ADDENDUM NO. 1

Water, Sewer, paving, Drainage, and Street Light Improvements to serve
South Oak Grove Estates, Section Six
CITY PROJECT NO.: 102739

Addendum No. 1: Issued May 17, 2021

CITY OF FORT WORTH, TEXAS
 SOUTH OAK GROVE ESTATES SECTION SIX
 SANDALWOOD DRIVE PLAN AND PROFILE

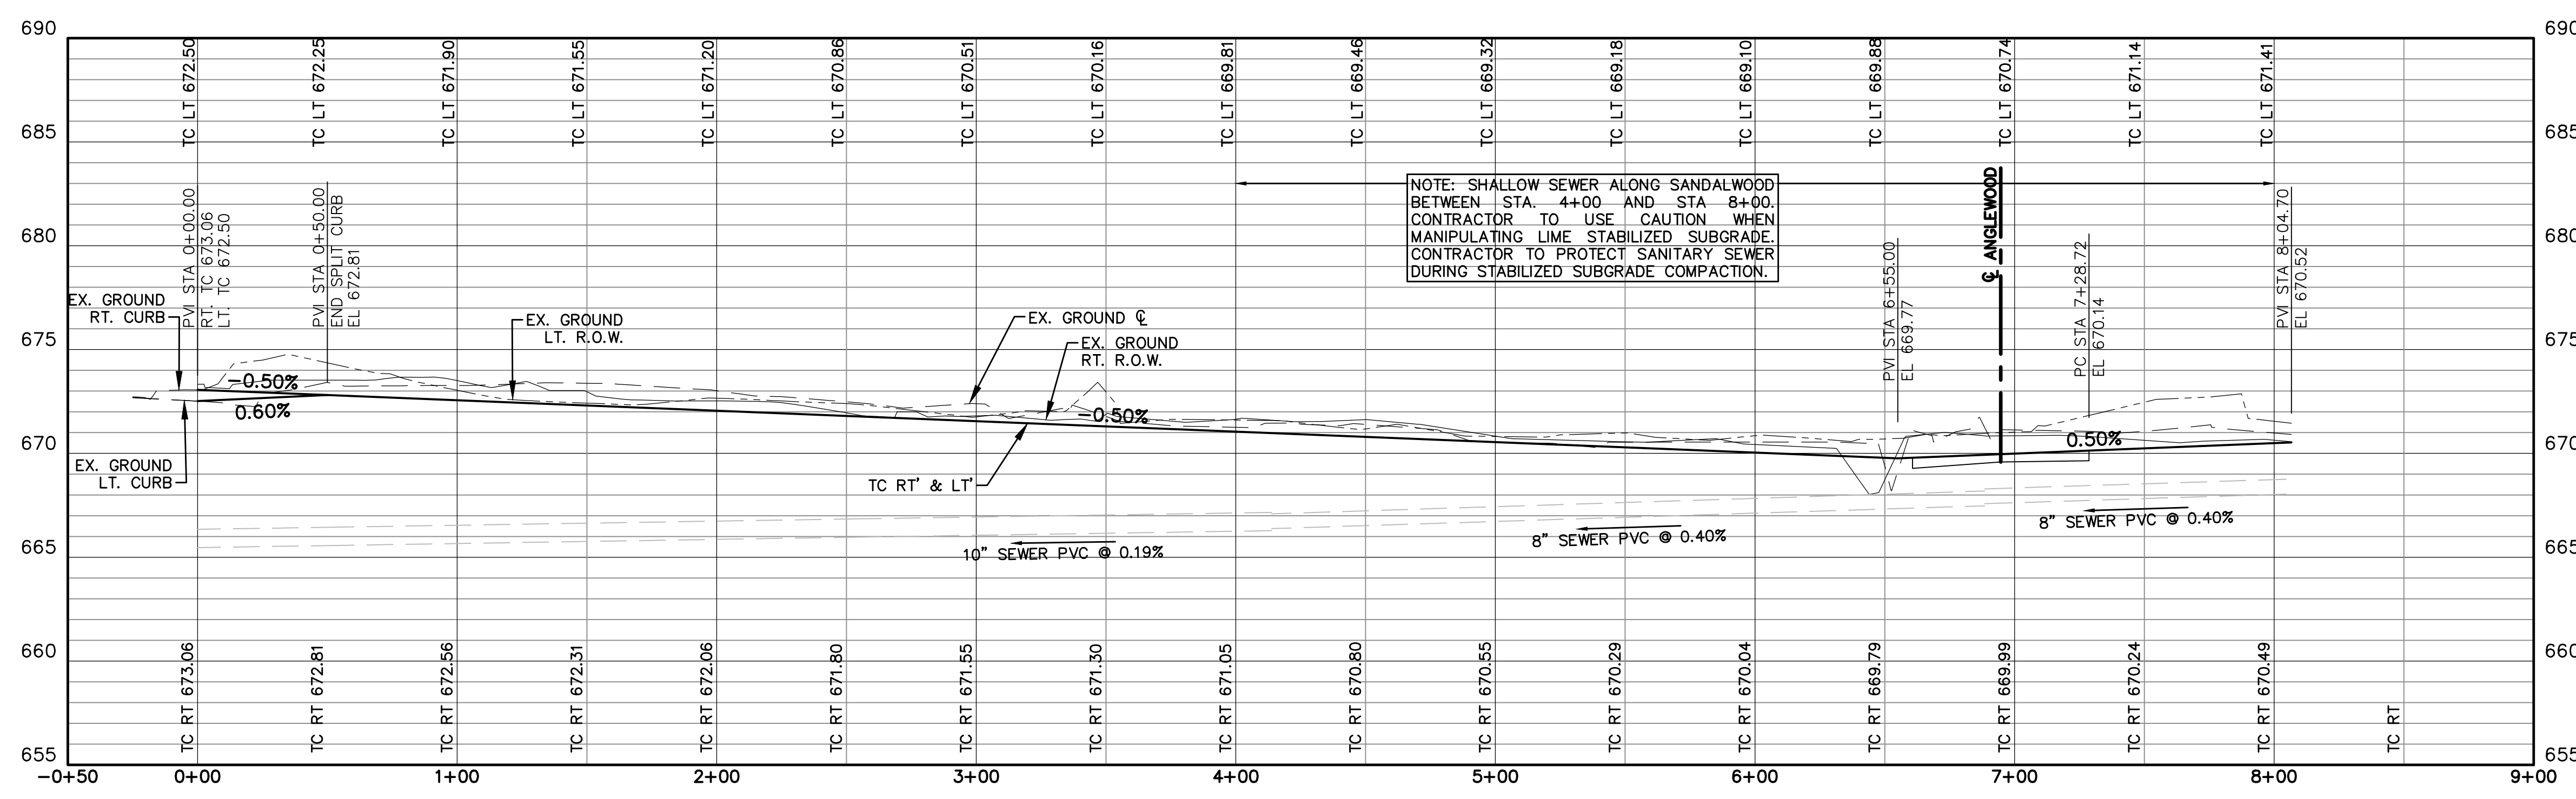
Sheet 21
Sheet 27

Modified the lime stabilization construction note.
Modified contraction joint spacing.
